PG&E Letter DIL-03-002

Docket No. 72-26
Diablo Canyon Independent Spent Fuel Storage Installation
Revised and Supplemental Responses to NRC Request for Additional Information
for the Diablo Canyon Independent Spent Fuel Storage Installation Application
(TAC No. L23399)

**Revised Response to Request for Additional Information for
Diablo Canyon Independent Spent Fuel Storage Installation (ISFSI)
License Application**

**Supplemental Information to Request for Additional Information for
Diablo Canyon Independent Spent Fuel Storage Installation (ISFSI)
License Application**

Terminal Procedures

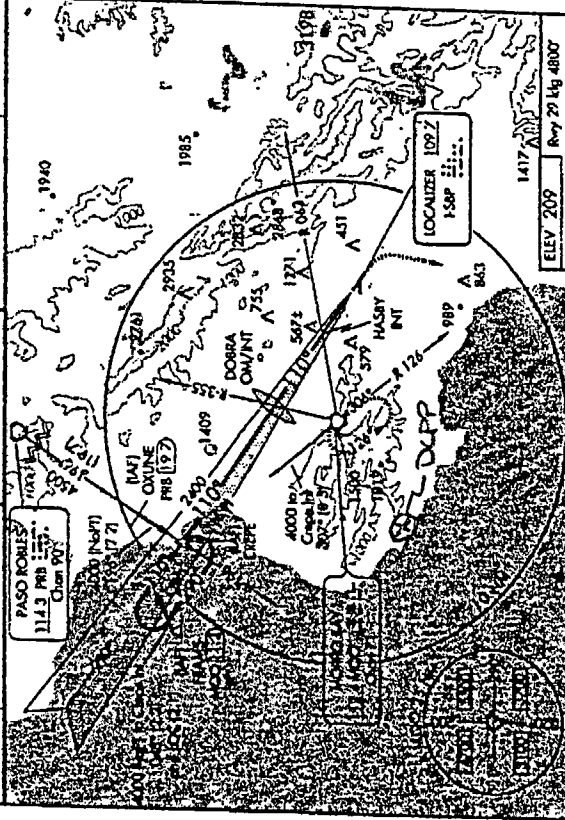
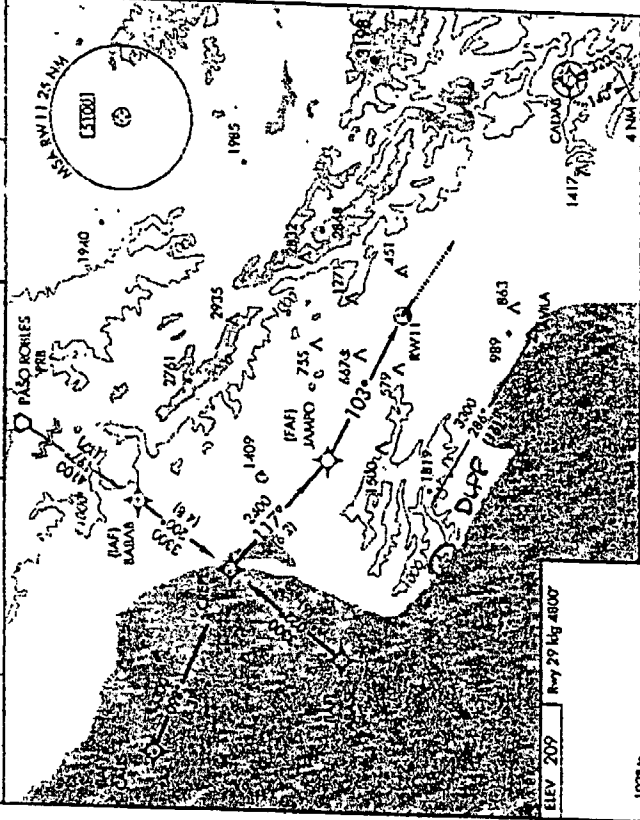
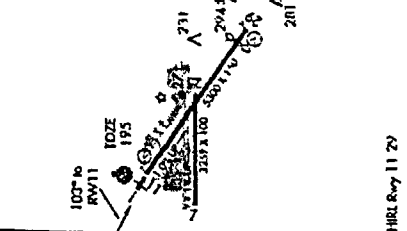
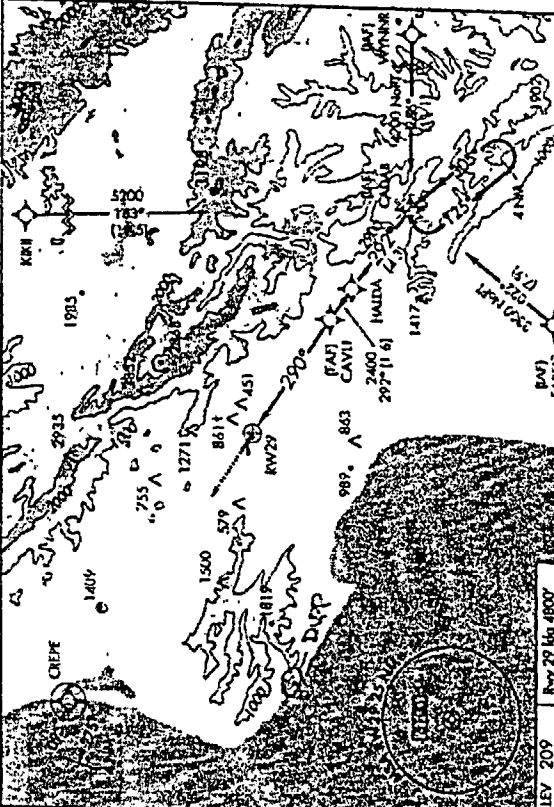
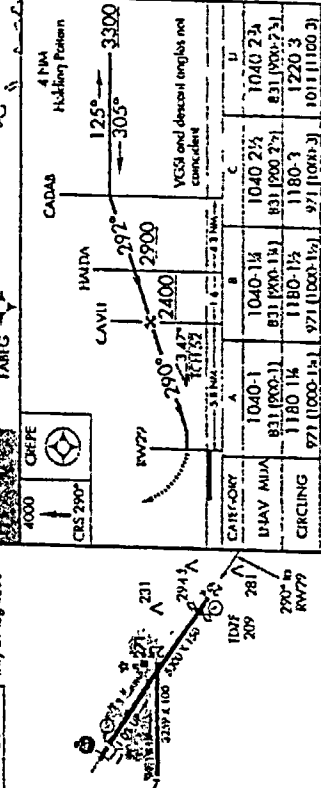
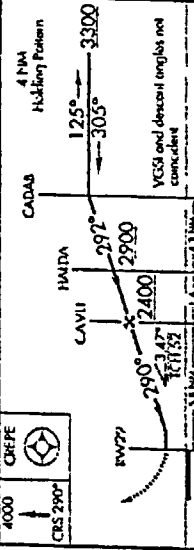
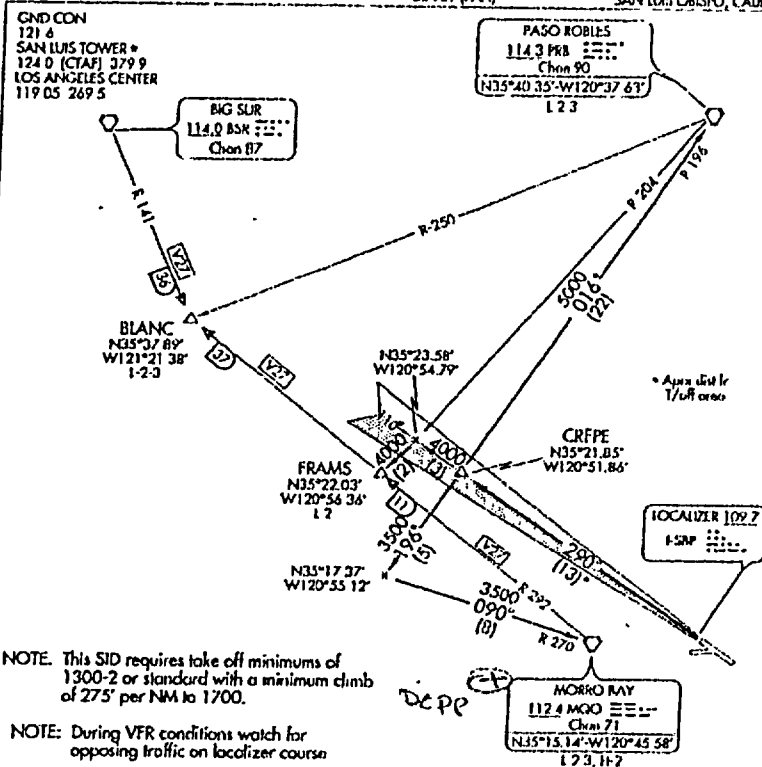
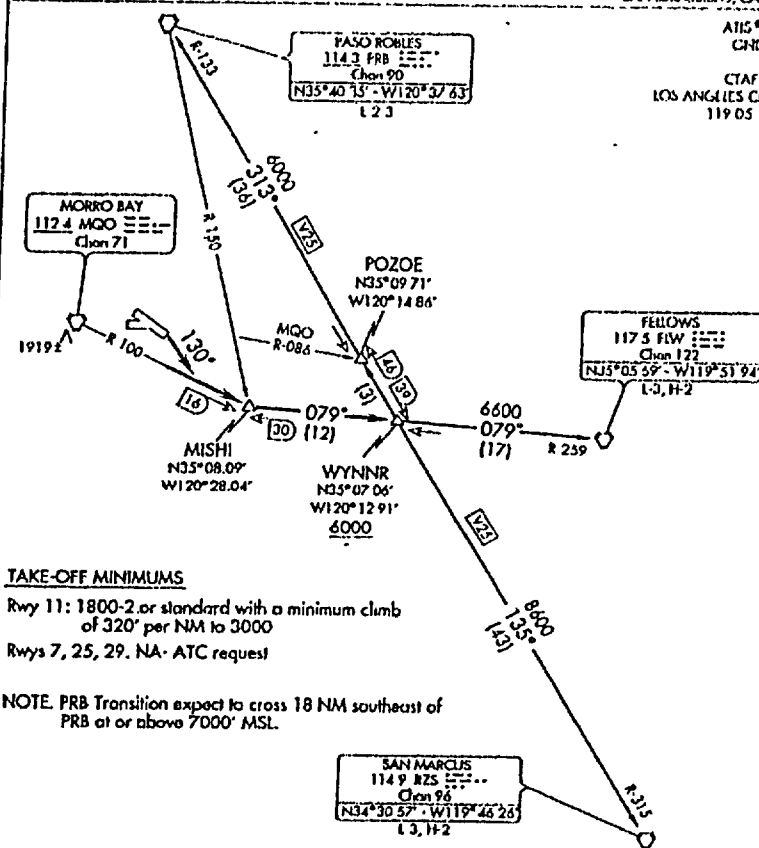
Need plot for holding patterns for arrivals and missed approach (e.g., CREPE and CADAB intersections and Morro Bay VOR) relative to the proposed site.

The terminal procedures are included as Attachment 1 to this submittal. DCPD is not shown on approach charts, but its location has been marked.
